**Eugene School District 4J
ROOSEVELT MIDDLE SCHOOL**
680 East 24th Avenue
Eugene, OR 97405
CIP No. 410.566.001

ADDENDUM NO. 3

This Addendum forms a part of the Contract Documents and modifies the original Bidding Documents dated February 18, 2015 as noted below. Acknowledge receipt of this Addendum in the space provided on the Bid Form. Failure to do so may subject the Bidder to disqualification.

MASONRY WALL

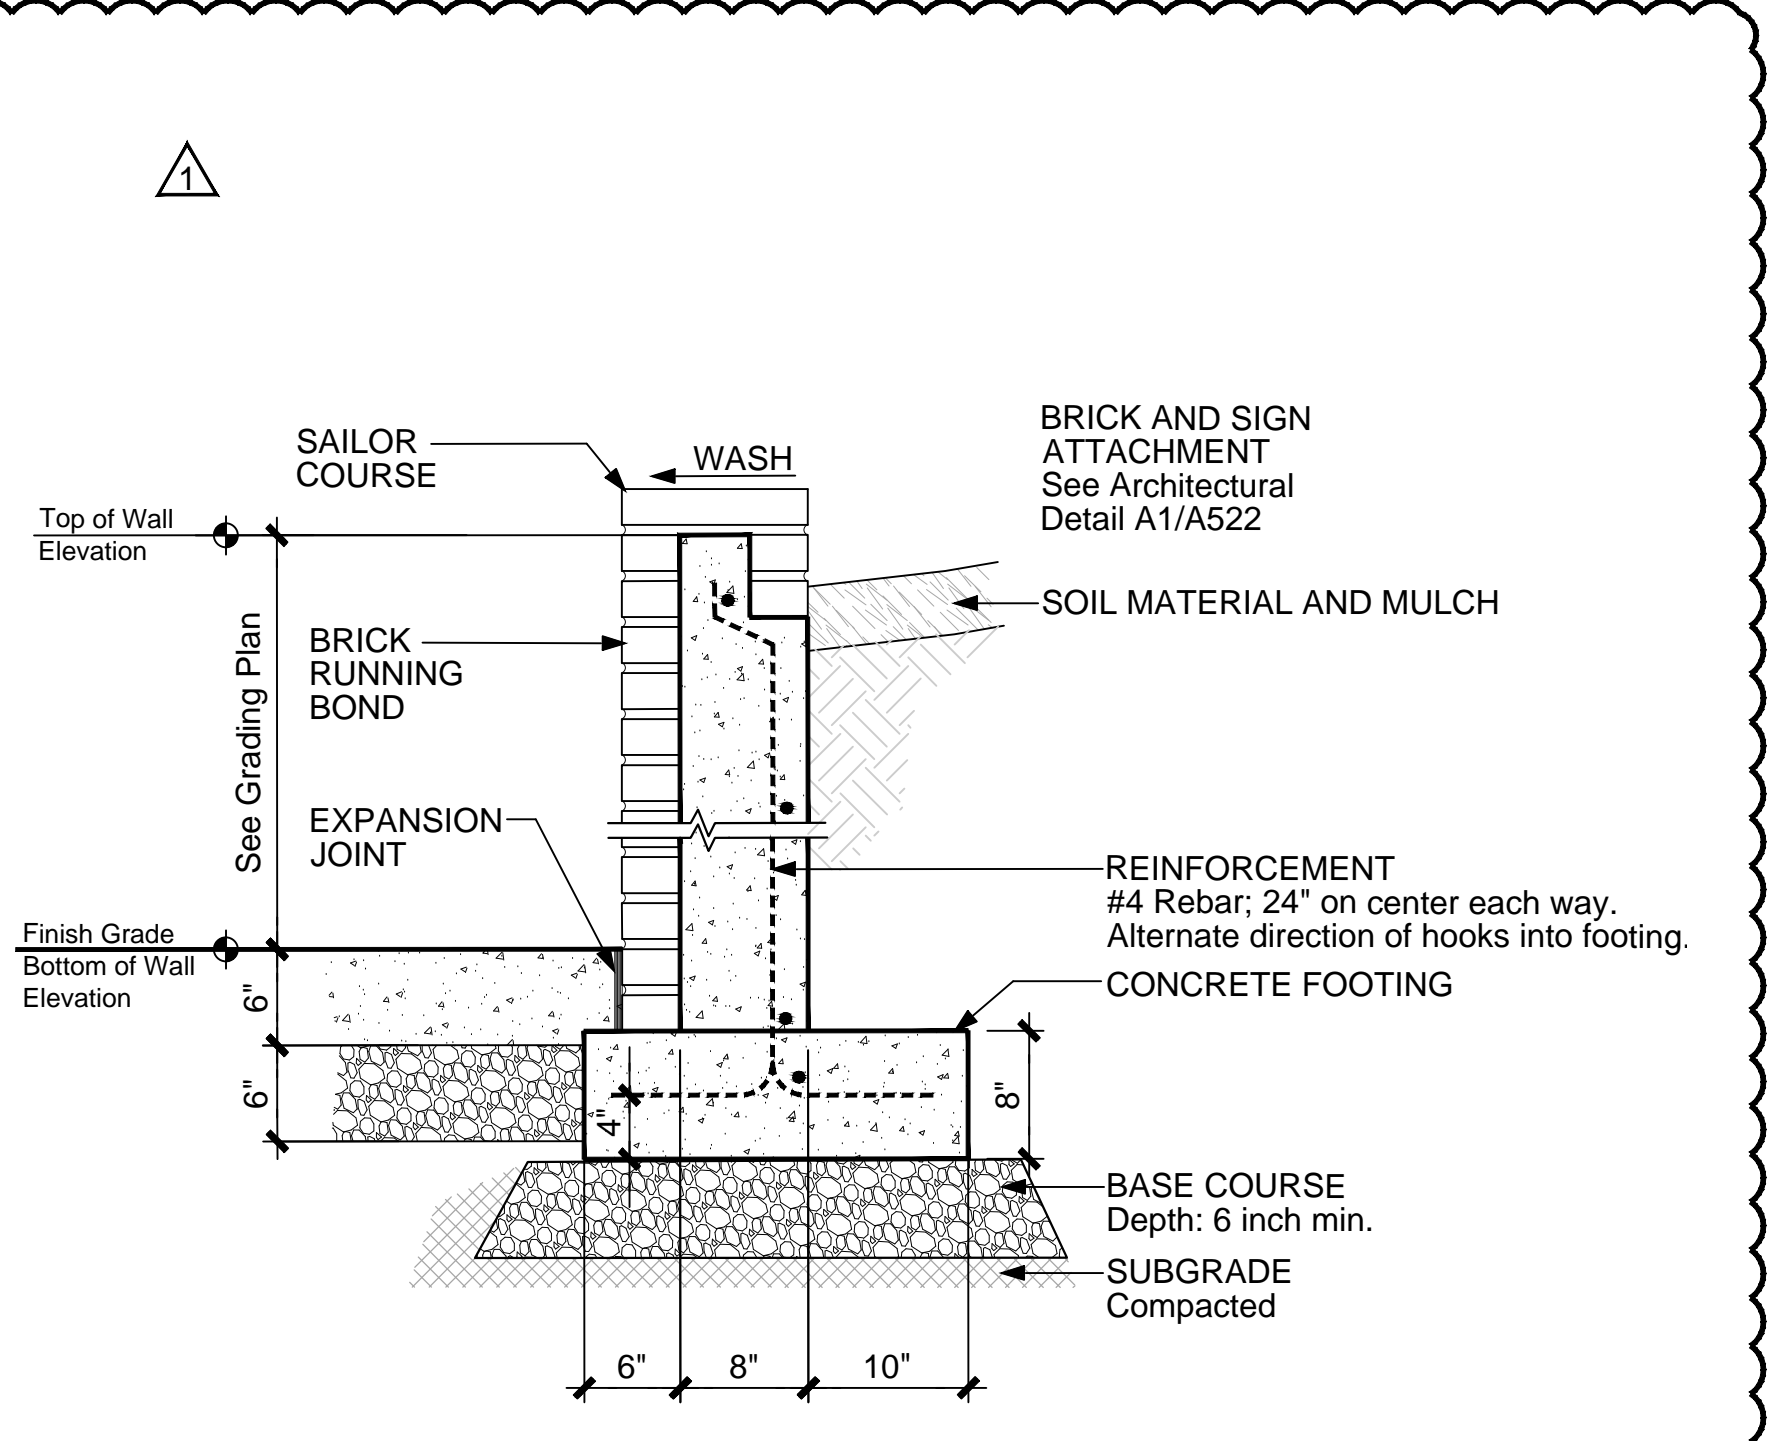
- A. Replace Sheet with attached new Sheet L-106.2. Clarification: Updated Detail #1. Updated Detail #2. Updated Detail #6. Added Detail #7 – Masonry Wall.
